County of Fairfax, Virginia

STAFF REPORT

APPLICATION PRC 86-C-121-04

APPLICANT: Reston Spectrum, LLLP and Harris Teeter Properties, LLC

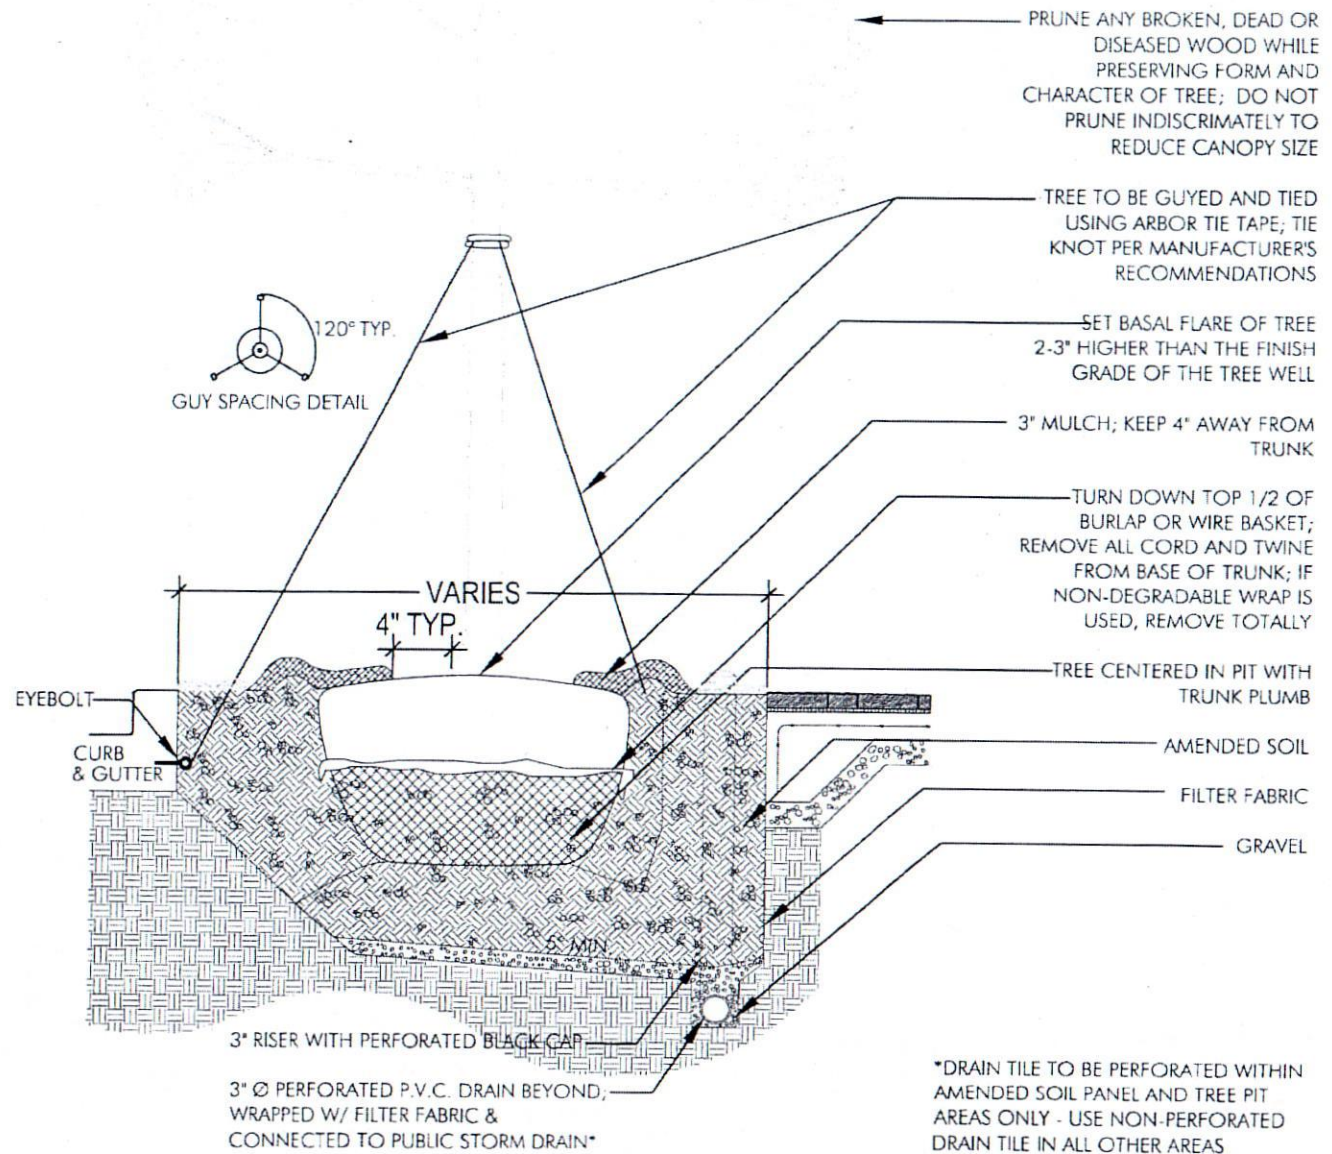
1. **Comment:** The street tree planting detail specifies structural soil in a situation that does not require support of paving over the root zone of proposed trees. When this was brought to her attention in a phone conversation, Trini Rodriguez acknowledged the error and sent a different Street Tree Planting detail (attached). The detail does not stand along, however, as the width of the planting space varies and length and depth are not noted.

Recommendation: Request that references to streetscape sections, showing planting space widths, and proffers requiring minimum soil volumes be included in the Street Tree Planting detail to provide more complete specifications for street tree planting.
